City of Portland, Maine – Building or Use Permit Application 389 Congress Street, 04101, Tel: (207) 874-8703, FAX: 874-8716

Location of Construction: 27 Clifton St		Owner: Lee, Gaston & Manzelli, Albert		Phone:	Permit No: 980085
Owner Address:		Lessee/Buyer's Name:		Phone:	<div style="border: 2px solid black; padding: 5px; text-align: center;"> PERMIT ISSUED FEB - 5 1998 </div>
Contractor Name: Donahue Painting & Remodeling		Address: 557 Roosevelt Trail Windham, ME 04062		Phone: 892-7645	
Past Use: 3-fam (?)		Proposed Use: Same		COST OF WORK: \$ 3,200.00	PERMIT FEE: \$ 35.00
Proposed Project Description: Construct Fire Escape		<i>3fam - ok see mirafiche - previously approved AS three unit</i> Signature: <i>[Signature]</i>		FIRE DEPT.: <input checked="" type="checkbox"/> Approved <input type="checkbox"/> Denied	INSPECTION: Use Group <i>A2</i> Type: <i>5B</i> <i>BOCA 407</i> Signature: <i>[Signature]</i>
				PEDESTRIAN ACTIVITIES DISTRICT (P.A.D.)	
Permit Taken By: Mary Gresik		Date Applied For: 21 January 1998		Zoning Approval: <i>Reviewed under New Exterior Code Section</i> Special Zone or Reviews: <input type="checkbox"/> Shoreland <i>14-440</i> <input type="checkbox"/> Wetland <

STANDOFF POST BASES

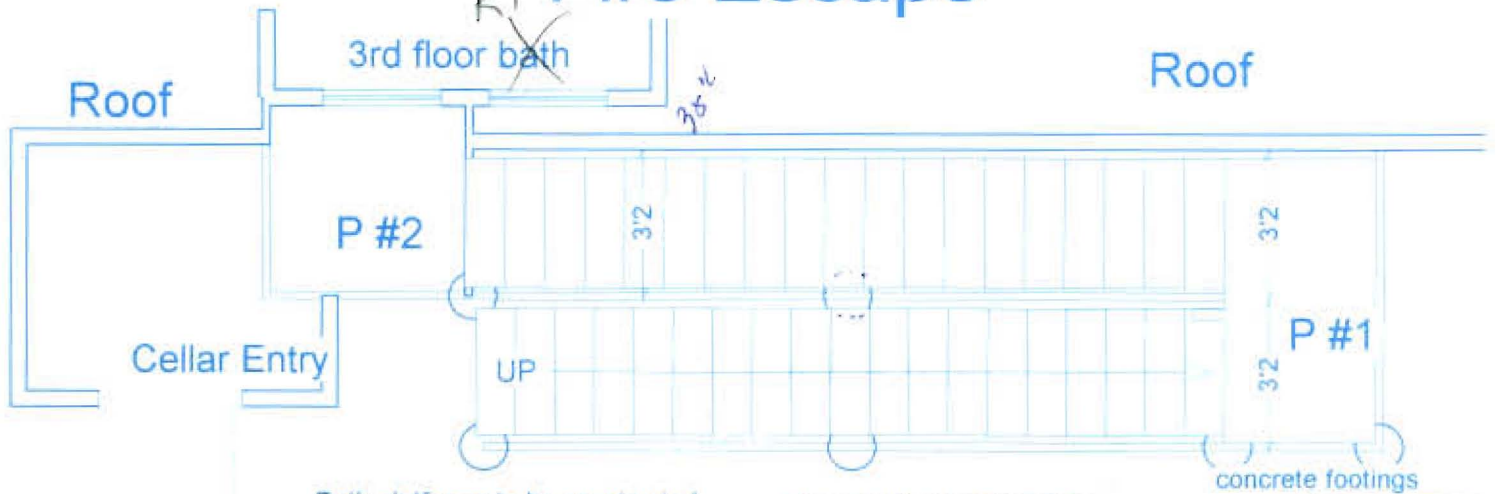
*Merke -
this base is ok -
He does need the
washers on them +
he should have set
the post so
it sets even-
ly on base.
Also 1/2" dia
anchor bolts.*

EXTERIOR STAIRWAY

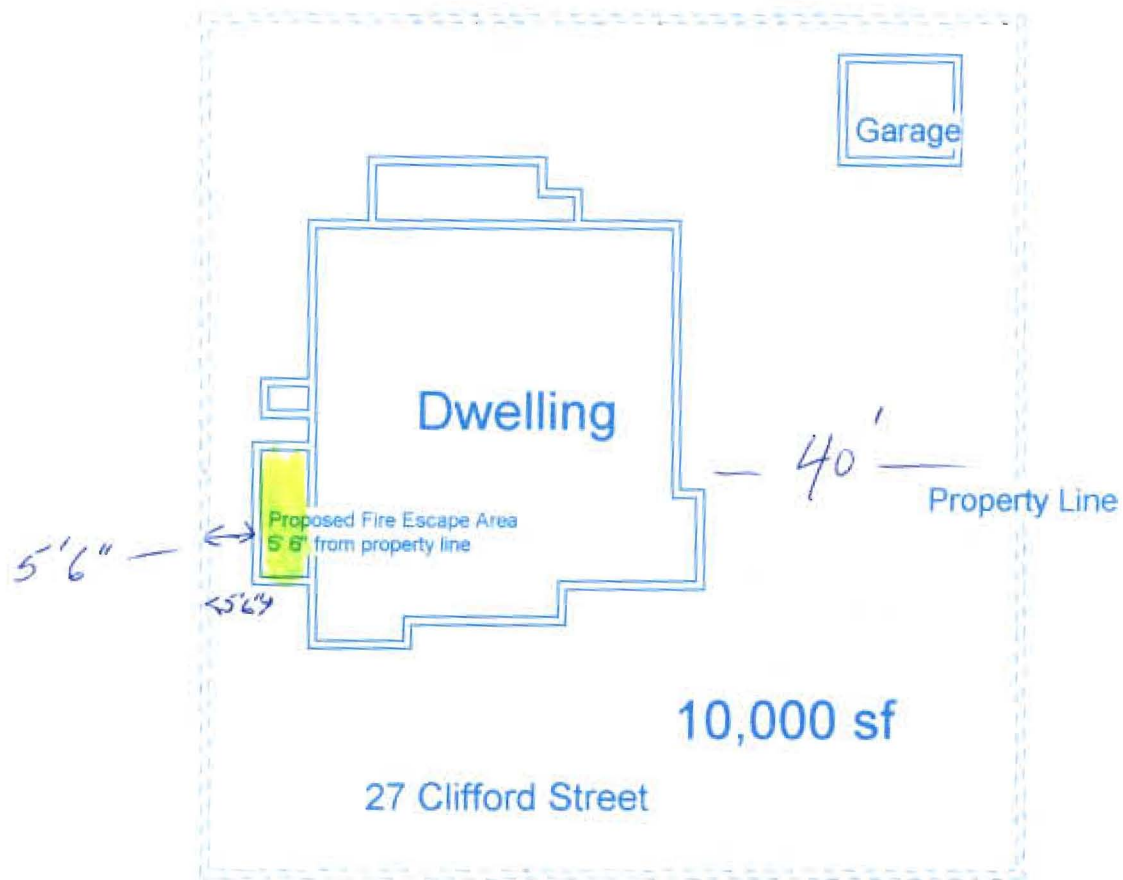
7" MAX RISE
11" MIN TREAD

Proposed Fire Escape Area
5' 6" from property line

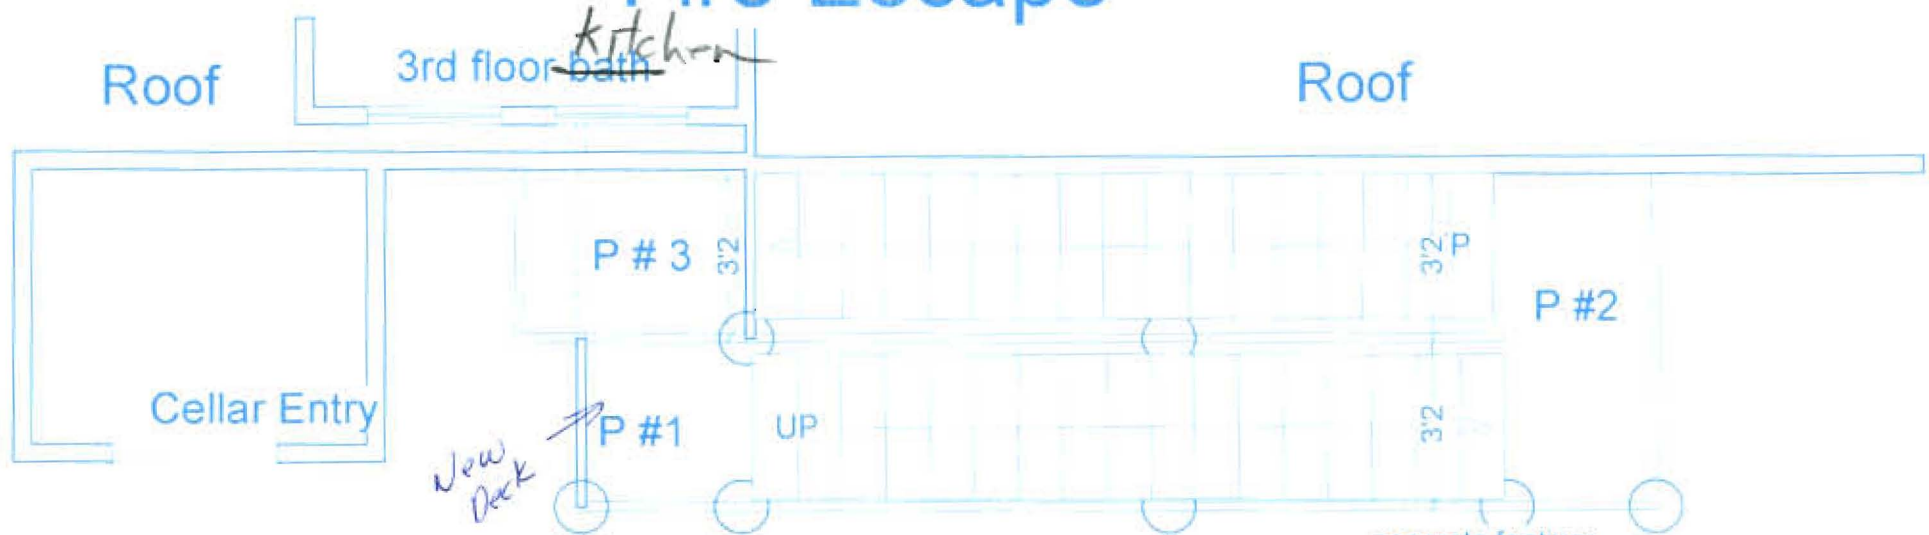
*With Plan Amendment
Area remains the same
additional Cost of \$250.00*
